SOUTH-CENTRAL RAILBELT AREA, ALASKA (HYDROELECTRIC POWER), UPPER SUSITNA RIVER BASIN

INTERIM FEASIBILITY REPORT

APPENDIX 1
PART 2

SECTION G. MARKETABILITY ANALYSES
SECTION H. TRANSMISSION SYSTEM
SECTION I. ENVIRONMENTAL ASSESSMENT FOR TRANSMISSION SYSTEMS

FIGURE 7

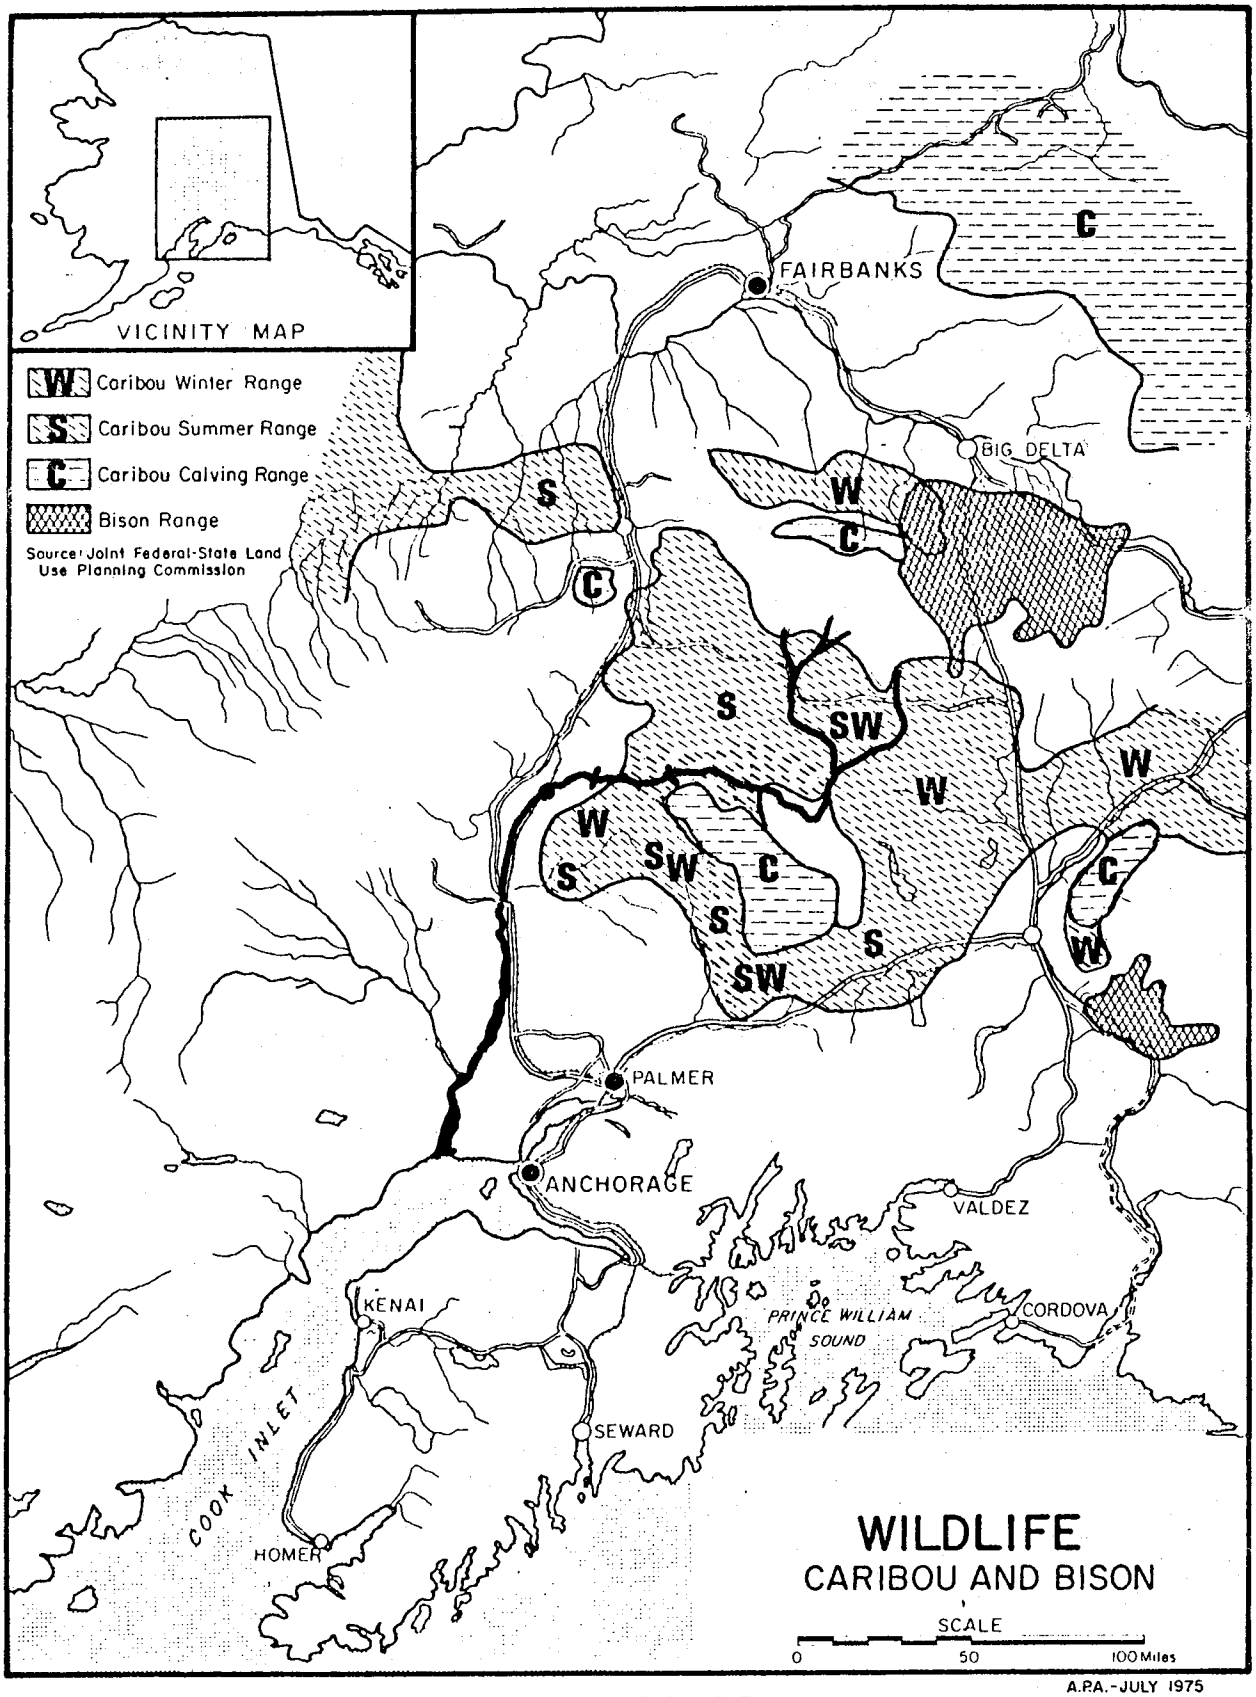
138 Page 24, Figure 7 - The white (unmarked) area in the center of the caribou range map is both summer and winter range. This area should be so indicated.

FIGURE 15

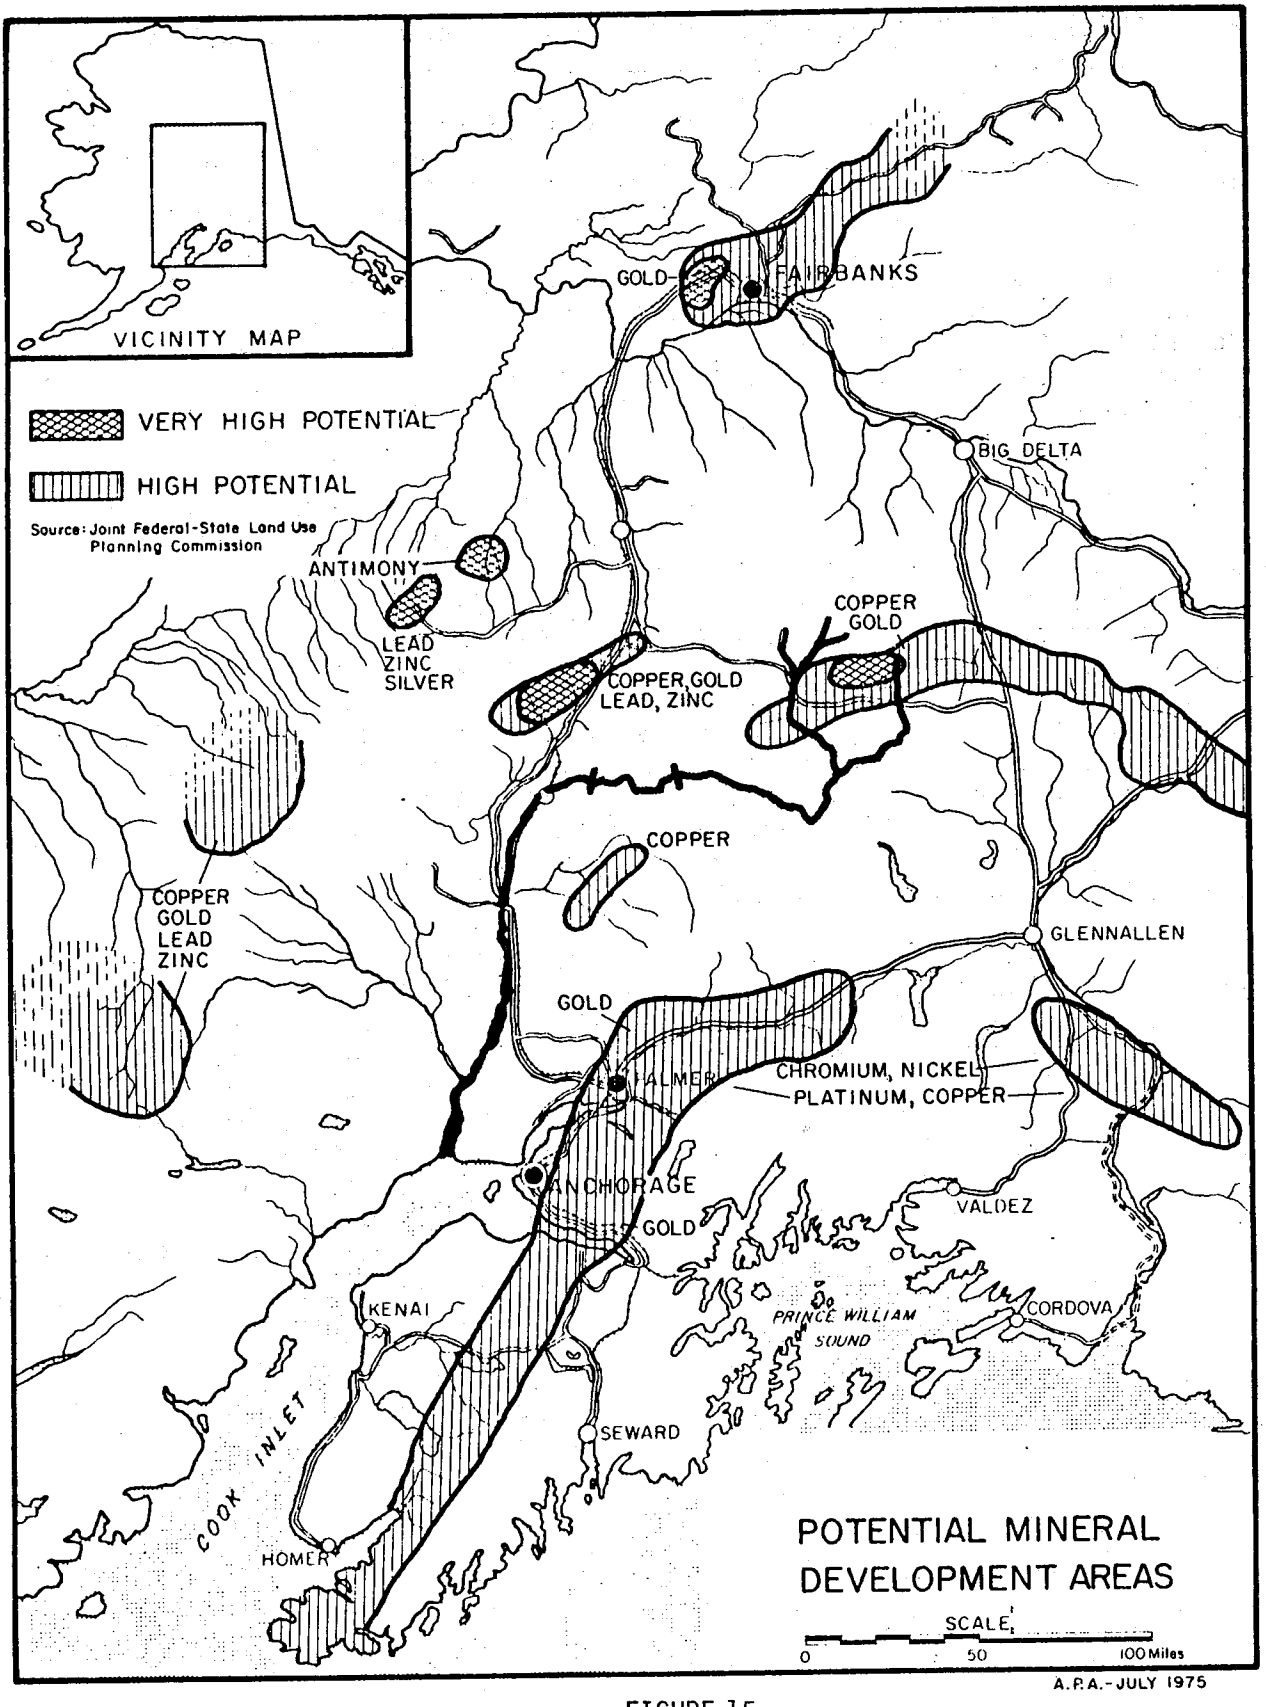
A transmission corridor is indicated in figure 15 as possibly passing through the Copper River Basin served by the Copper Valley Electric Association which has plans to increase their service by a new hydroelectric project at Solomon Gulch near Valdez with a transmission line to the Copper River Basin. The coordination of these two transmission or power systems should be explained in the final. 78

The second reason we consider the alternatives for power transmission corridors inadequate is that there is no analysis of impacts. Figure 15 graphically presents the alternatives. The text then states that the proposal was selected on the basis of cost, reliability, and potential environmental impact, but none of the needed information is presented. An environmental statement should present enough information for the reader to understand why the proposal was selected over the alternatives. 93
